CW – 2013 – 03										DRAFT OPERATING TEST COMMENTS										SCENARIOS									
Scenario Set	1. ES	2. TS	3. Crit	4. IC	5. Pred	6. TL	7. L/C	8. Eff	9. U/E/S	10. Explanation (See below for instructions)																			
1										See attached comments.																			
2																													
3																													
4																													
<p><u>Instructions for Completing Matrix</u></p> <p>This form is not contained in or required by NUREG-1021. Utilities are not required or encouraged to use it. The purpose of this form is to enhance regional consistency in reviewing operating test scenario sets. Additional information on these areas may be found in Examination Good Practices Appendix D. Check or mark any item(s) requiring comment and explain the issue in the space provided.</p> <ol style="list-style-type: none"> ES: ES-301 checklists 4, 5, & 6 satisfied. TS: Set includes SRO TS actions for each SRO, with required actions explicitly detailed. Crit: Each manipulation or evolution has explicit success criteria documented in Form ES-D-2. IC: Out of service equipment and other initial conditions reasonably consistent between scenarios and not predictive of s

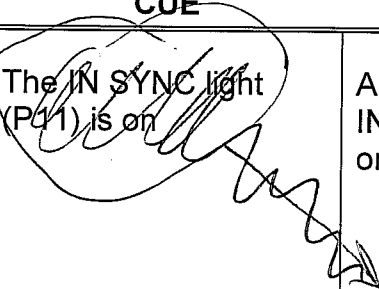
Weak - what are Crt Steps?
